KEMPS CREEK ESTATE – SSD-9522 MOD 3

Response to Request for Information

Table 1 DPE Comments and Response Table

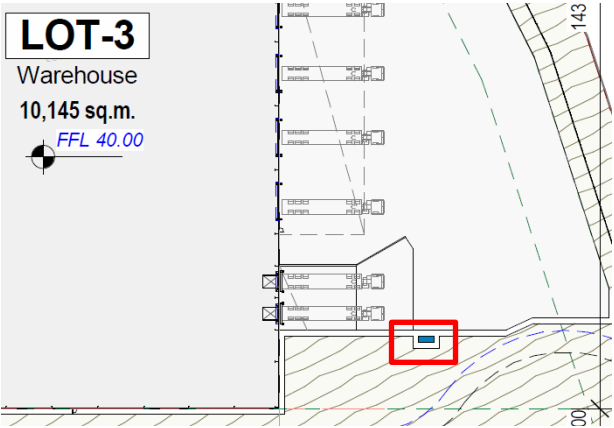
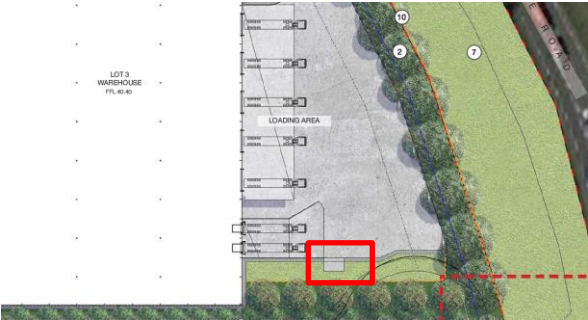
Please provide justification for the increase in car parking spaces while the overall GFA is proposed to be reduced.	<p>The known tenant for Warehouse 2, has a known employment base and the amount of car parking provided is a specific tenant requirement. They require more spaces due to the anticipated number of employees for their operation. This will bring more jobs to the Kemps Creek Estate and the broader Mamre Road Precinct.</p> <p>The Traffic Impact Assessment has also demonstrated that the proposed car parking spaces can be satisfied at the entry point into the estate. Refer Appendix C.</p> <p>Below is a comparison of the parking rates within both the Mamre Road and Mamre South DCPs.</p> <p><u>Mamre Road DCP</u></p>	<p>Section 8.3 of MOD 3 Report</p> <p>Appendix C of MOD 3 Report</p>

Comment	Response	Section
	<ul style="list-style-type: none"> Industries: 1 space per 200m2 of GFA or 1 space per 2 employees, whichever is greater. Warehouse or distribution centres: 1 space per 300m2 of GFA or 1 space per 4 employees, whichever is the greater. Ancillary office space: 1 space per 40m2 of GFA <p><u>Mamre South DCP</u></p> <ul style="list-style-type: none"> Warehouse or distribution centres: 1 space per 300m2 of GFA Office: 1 space per 40m2 of GFA Industries: 1 space per 200m2 of GFA 	
<p>Clarify why the receiving office and despatch office for Lot 2 are included in the warehouse floor area and not office floor area; similarly, the dock office for Lot 4.</p>	<p>Loading docks related to offices and/or workshops (within the warehouse building envelope) are considered ancillary areas to the warehouse, due to their operational functions. These ancillary spaces often grow, shrink or shift during detailed design when the warehouse fitout is being developed. For example, this is happening with the known tenant for Lot 2, which the proponent is currently in discussions with. By including these areas within the warehouse, the overall area of the warehouse will not change for CC certification purposes.</p>	<p>N/A</p>

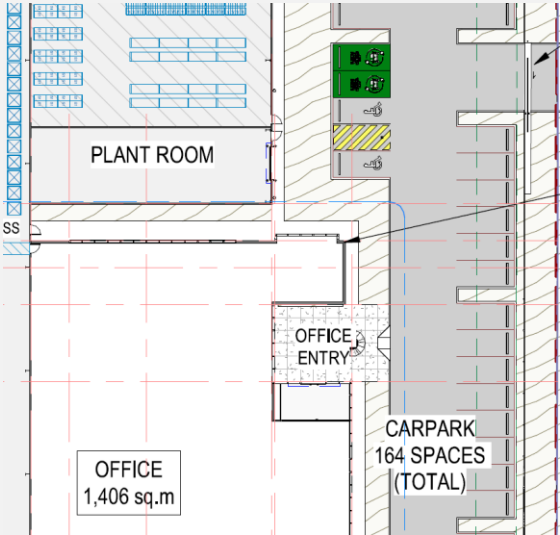
<p><u>(b) Applicable Development Control Plan</u></p> <p>The applicable Development Control Plan for the site is the Mamre Road Precinct DCP. The Penrith DCP 2014 does not apply to the subject site or application.</p>	<p>Not agreed – the applicable DCP for the site is the site-specific Mamre South DCP.</p> <p>Many controls within the Mamre South DCP are actually the same as controls within the Mamre Road Precinct DCP, such as building setback controls.</p>	<p>Section 6.4.1 of MOD 3 Report</p>
<p><u>(c) Proposed Lot and Warehouse Reconfigurations</u></p>	<p>The issue in relation to warehouse allotments not having adequate frontage to a public road</p>	<p>Section 4 of MOD 3 Report</p>

Comment	Response/Action	Reference
<p>In letter dated 29 November 2021 issued in response to the lodgement of MOD 2 to the SSDA, Council raised objection to the provision of warehouse allotments that are not provided with adequate frontage to a public road and in this regard, the addition of the north-south interallotment road with teardrop/cul-de-sac is an improvement on the approved layout (subject to further design resolution related to pedestrian access and safety matter as raised in Section 4, Traffic Management Advice, below).</p>	<p>has been addressed through the inclusion of the teardrop cul-de-sac.</p> <p>The proposed modification seeks to directly address Condition B18 of SSD-9522, which was imposed by Transport for NSW (TfNSW) requiring that all access to lots north of Bakers Lane be obtained from a single roadway so as to reduce crossings onto Bakers Lane.</p> <p>The updated Estate layout introduces a new cul-de-sac connection for this purpose, at a suitable distance from the future signalised intersection between Mamre Road and the SLR, to ensure there are no disruptions to traffic conditions at this critical node.</p>	<p>Appendix A of this Response Table</p>

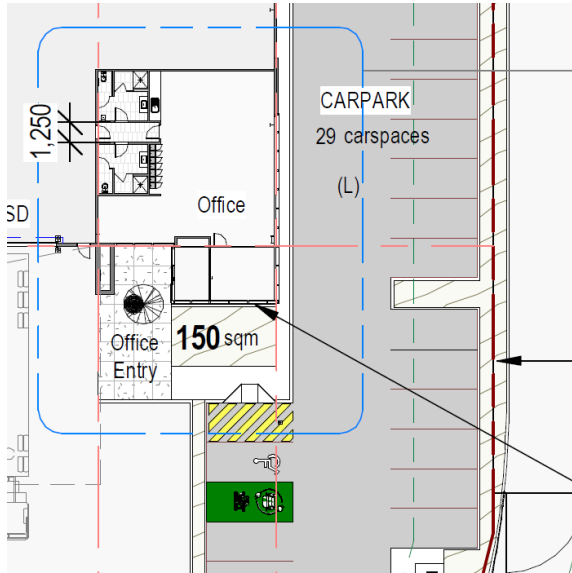
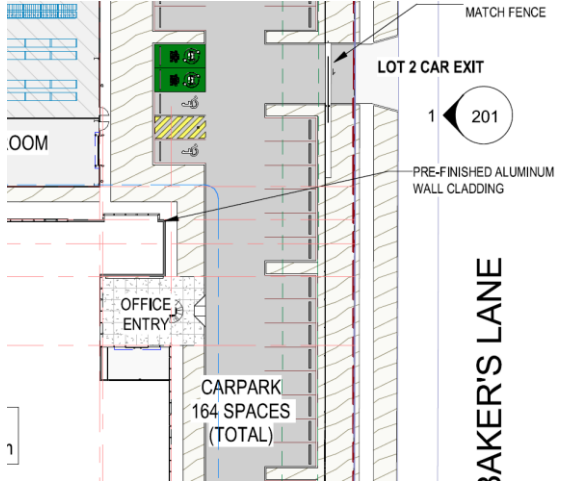
<p>Council recommends that the Department does not support (for all proposals) battle-axe style warehouse lots including those accessed by private roads or driveways which do not replicate the DCP design requirements including those stipulated for roadway widths, setbacks and landscaping.</p>	<p>The proposed Lot 1-4 layout under MOD 3 is a direct response to Condition B18 and TfNSW's requirements for a new cul-de-sac.</p> <p>The proposed modification seeks to directly address Condition B18 of SSD-9522, which was imposed by TfNSW requiring that all access to lots north of Bakers Lane be obtained from a single roadway so as to reduce crossings onto Bakers Lane.</p>	<p>Section 5 of MOD 3 Report</p> <p>Section 8.1 of MOD 3 Report</p> <p>Appendix A of this Response Table</p>

Comment	Response/Action	Reference
	<p>Condition B18 – Internal Road Network and Southern Link Road, states:</p> <p><i>B18. Prior to the commencement of any construction (excluding bulk earthworks) on lots 1-4 north of Bakers Lane, the Applicant must prepare a concept design demonstrating how the internal road network can provide access to lots 1-4 and link to the future Southern Link Road. The design must be prepared in consultation with TfNSW and to the satisfaction of the Planning Secretary.</i></p> <p><i>Note: The concept design must address access arrangements to lots 1-4 both with and without the future Southern Link Road, including ensuring any access points are an appropriate distance from signalised intersections.</i></p> <p>The key controls within the DCP in relation to roadway widths, setbacks and landscaping are all met in the proposed layout and design.</p>	
<p>Careful consideration is to be given to the design of warehouse buildings and office areas to ensure that these are well designed, high in amenity (internal and external) incorporate end of trip facilities and are accessible at each level.</p>	<p>The design of the Lots 1-4 within MOD 3 ensure Condition B18 is satisfied whilst also achieving a well designed warehouse configuration and layout. The proposed warehouses will be supported by office areas that located in accessible locations in relation to car parking areas and pedestrian access routes. The Lot 1-4 layout is well supported by landscaping which soften the edge along the street frontage.</p>	<p>Section 5 of the MOD 3 Report</p>

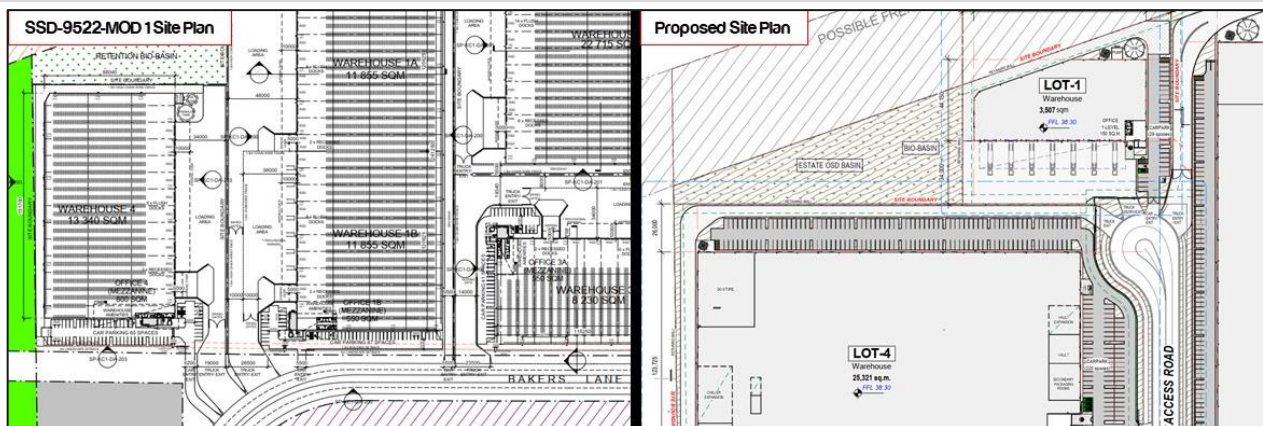
<p><u>(g) Heights and Roof Top Plant Machinery</u></p> <p>It is raised for the Department's consideration that the approved Height of Buildings is to be measured from Natural Ground Level and is to include rooftop plant machinery including screening devices and air conditioning units.</p>	<p>The height of roof-top-plant varies. The top of the highest plant sits at 3.5m above the warehouse ridge level which is inclusive of a perimeter screen up to 1m above the top of the unit. The highest RL of the building inclusive of the plant is at 18.1m above the Finished Floor Level (14.6m + 3.5m)</p>	<p>Appendix A of this Response Table</p>

Comment	Response/Action	Reference
<p>To avoid subsequent MODs and issues with future DAs (submitted to Council) not complying with approved Heights expressed in consent no. SSD-9522 (as modified), Council recommends that any height limit expressed in a consent condition is to clarify that height is from a defined approved Finished Floor Level, or from Natural Ground Level; and is to clarify that height does or does not include roof mounted plant and any associated screening devices.</p>	<p>The top of building height levels are measured from the Finished Floor Level.</p>	<p>Appendix A of this Response Table</p>
<p>Roof top plant is not indicated in the provided architectural photo montages and is not included in the Geoscapes Visual Impact Addendum Report. Council recommends that the plans and reports be amended to address this matter and to allow a thorough assessment by the Department.</p>	<p>The Visual Impact Assessment has been updated by Geoscapes to include the rooftop plant proposed within Lots 2 and 4.</p> <p>The VIA concludes that the roof equipment to Warehouses 2 and 3 is most visible from Mamre Road as demonstrated within VP 21. However, when comparing the impact of the roof equipment compared to the overall bulk and scale of the previous MOD1 scheme, it is not considered to be a significant visual detractor.</p>	<p>Appendix B of this Response Table</p>

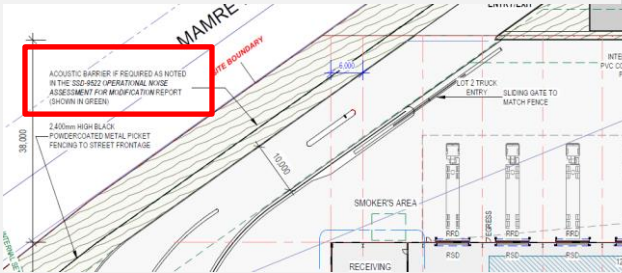
Comment	Response	Section
	 <p>The Functional Layout Plan SLR/Bakers Lane MOD 3 provided in the MOD 3 Report (refer Appendix G of MOD 3 Report) confirms the distance to the future SLR intersection from proposed cul-de-sac is at 146.65m, as shown below. This is also compliant in terms of Australian Standards and clarified in consultation with TfNSW.</p> 	
<p>It is recommended that the Department seek clarification as to why the midblock volumes of Bakers Lane (west of Lot 4/ Access Road) shown in the 2036 SLR / Bakers Lane / North-South Road 01 intersection (Figure 22) are less</p>	<p>It is noted that the midblock PM count, west of the Lot 4 Access Road (2026) is <i>slightly lower than the SLR / Bakers Lane (2036) as it is sourced from the strategic model EMME output. This discrepancy can be in response to other Local and Regional connections assumed for the EMME model in the</i></p>	<p>N/A</p>

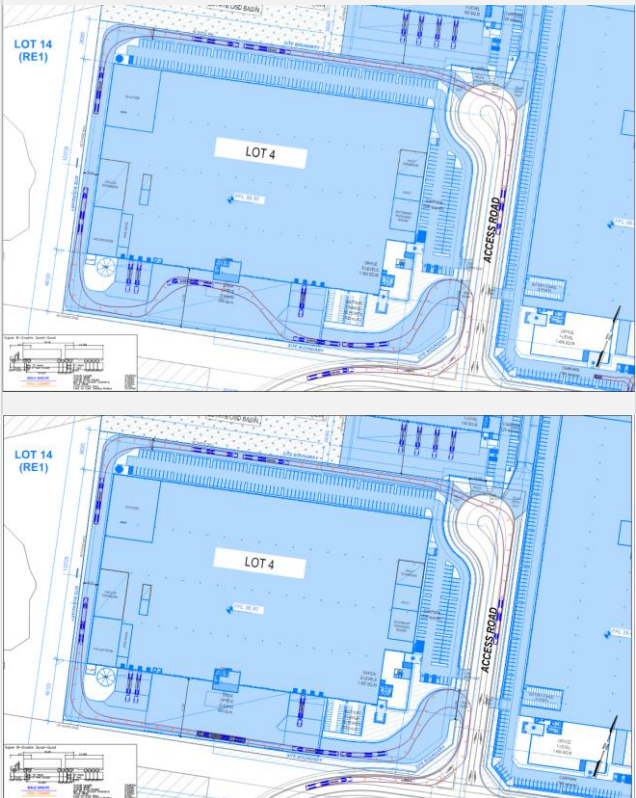
<p>Modelling</p> <p>TfNSW notes the modelling outputs provided are transposed versions and are missing key information. In order to undertake a more detailed review of the provided documentation, it is requested that all SIDRA results referred to in the supplementary traffic assessment are provided (including the Base</p>	<p>The SIDRA models have been provided as part of this Response Table to TfNSW. The models attached include:</p> <ul style="list-style-type: none"> ▪ P1840_MOD 4 SIDRAs_BL x Access Road_Interim_2026.sip9 ▪ P1840_MOD 4 SIDRAs_SLR x BL_Ultimate_2036.sip3 	<p>Appendix C3 and C4 of this Response Table.</p>

Comment	Response	Section
<p>models). This should include SIDRA output and raw SIDRA (.sip) files. This will enable our modelling and traffic teams to undertake a detailed review of the model to ensure that the inputs are accurate and supported. Further comments can be provided following the review of the models which may require the assessment to be updated.</p> <p><i>Recommendation</i></p> <p>It is requested the modelling be updated for a realigned access road (to Lots 1-4) and the SIDRA outputs and raw SIDRA (.sip) files are provided for further review. In addition, the supporting analysis for the future intersection (SLR and north south access road) is requested be provided in the same form.</p>		
<p>Noise Wall</p> <p>The plans indicate a 1600m long 3m high noise wall is proposed on the northeastern boundary adjacent to Lot 2 and north of lot 3. It is unclear if the noise wall is located within the boundary of the development. The noise wall is to be provided within the development boundary and should not encroach the proposed road reserve for the ultimate Mamre Road design. In addition the question is raised as to how the wall will be maintained in the future.</p> <p><i>Recommendation</i></p> <p>TfNSW requests clarification on where the noise wall is proposed to be located and further information is sought including civil plans showing the cross sections and clarification as to how the walls will be accessed and maintained.</p>	<p>The noise wall along the north eastern boundary will be provided within the development boundary of Lots 2 and 3, as indicated in the plans below. Please refer to drawing SP-KC1-DA-102 and SP-KC1-DA-103.</p> <p>Lot 2</p>  <p>Lot 3</p>	<p>Appendix A</p> <p>of this</p> <p>Response</p> <p>Table</p>

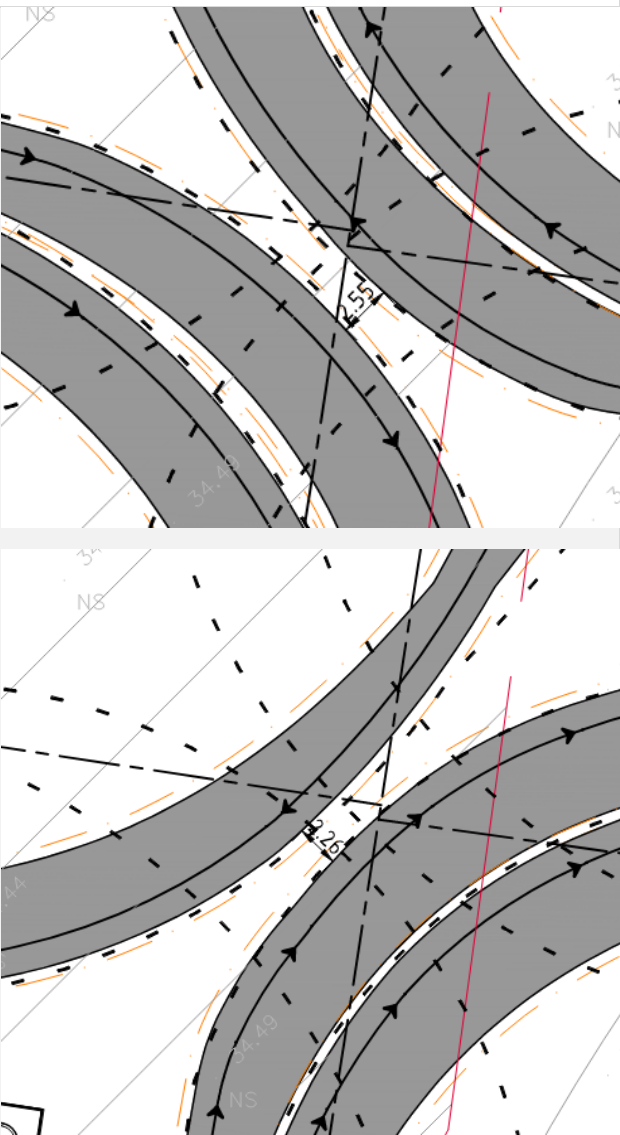
<p>Interim Scenario – access Lot 2</p> <p>Items 3&4 Table 2 of the Traffic Report provides some commentary on the access points. TfNSW understands that the access/egress from Lot 2 at Bakers Lane is restricted to Left in/Left out which is supported. However there remains safety concerns with the closely spaced heavy vehicle exit and the entry/exit to the carpark.</p> <p>In addition the swept path indicates a heavy vehicle would be required to swing from the western side of the driveway in order to achieve egress from the site. It is unclear how the driver know to do this.</p> <p><i>Recommendation</i></p> <p>It is recommended the applicant address the abovementioned concerns to the satisfaction of Council.</p>	<p>In this regard, the truck exit crossover and the driveway design have been amended to provide further separation between the two crossovers.</p> <p>We note that the amended driveway design will enforce truck drivers to swing out and make this exit movement as shown in belo swept path.</p> <p>We also confirm that the access design will be undertaken to Council's satisfaction at the detailed design stage of the project.</p>	<p>Appendix A of this Response Table.</p>

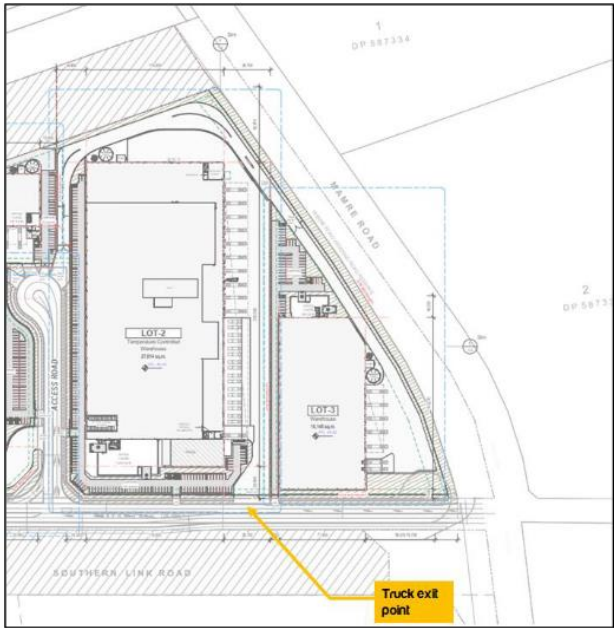
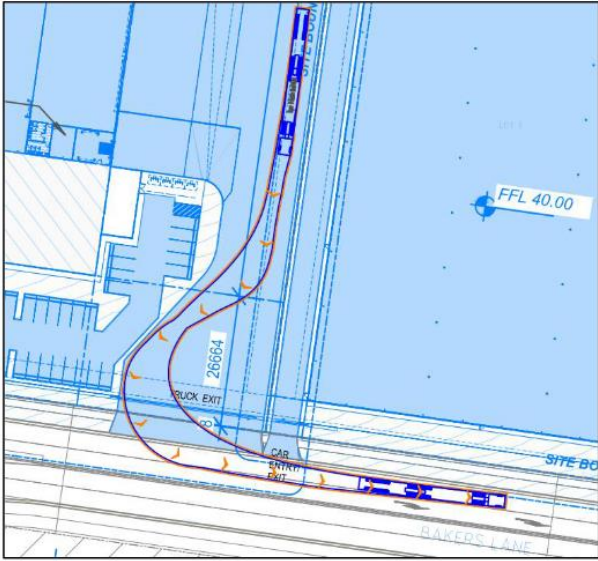
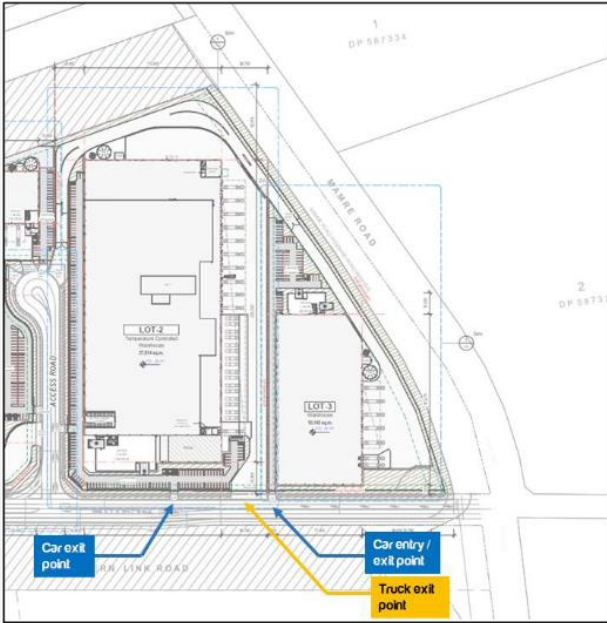
Comment	Response	Section
	<p>Please refer to Appendix D of the Transport Assessment which has the Swept Path Analysis on Super B-Doubles.</p> 	
<ul style="list-style-type: none"> North leg: <ul style="list-style-type: none"> The high angle of the north leg reduces visibility to the signals and is considered not acceptable The major movement will dominate the other movements which raises efficiency issues 	<p>The angle of the left turn lane provides a perpendicular entry to the SLR. The design arrangement considered to provides suitable visibility in accordance with Austroads and TfNSW.</p> <p>TfNSW to review the drawings submitted Co13362.02-SK4-06, at Appendix G of the MOD 3 Report.</p>	<p>Appendix G of the MOD 3</p>
<ul style="list-style-type: none"> Minimum distance required between turning vehicles 2 metres – clarify distance 	<p>Clearances of 2.55m and 2.26m has been achieved for the opposing turns, being greater than that required. The dimension is shown on the drawing.</p> <p>Refer drawing Co13362.02-SK4-08 & Co13362.02-SK4-09 and excerpts below.</p>	<p>Appendix G of the MOD 3</p>

<ul style="list-style-type: none"> It is unclear why a bus jump was not provided for the eastbound lane 	<p>Bus jumps are provided on both directions – TfNSW to review the drawings submitted Co13362.02-SK4-06, at Appendix G of the MOD 3 Report.</p>	<p>Appendix G of the MOD 3</p>
<ul style="list-style-type: none"> Why is there a chevron section on the south leg. This is not supported. 	<p>There is no proposed chevron - refer to submitted drawing Co13362.02-SK4-06, at Appendix G of the MOD 3 Report.</p>	<p>Appendix G of the MOD 3 Report</p>
<p><u>Pedestrian Safety</u></p> <p>The west pedestrian leg extends over 7 lanes of traffic. There needs to be consideration of a staged crossing. Alternatively if there is low pedestrian movements, the median has to be wide enough to store a person and to include a push</p>	<p>Pedestrian refuge as noted has been provided on both east and western pedestrian legs.</p> <p>TfNSW to review the drawings submitted Co13362.02-SK4-06, at Appendix G of the MOD 3 Report.</p>	<p>Appendix G of the MOD 3 Report</p>
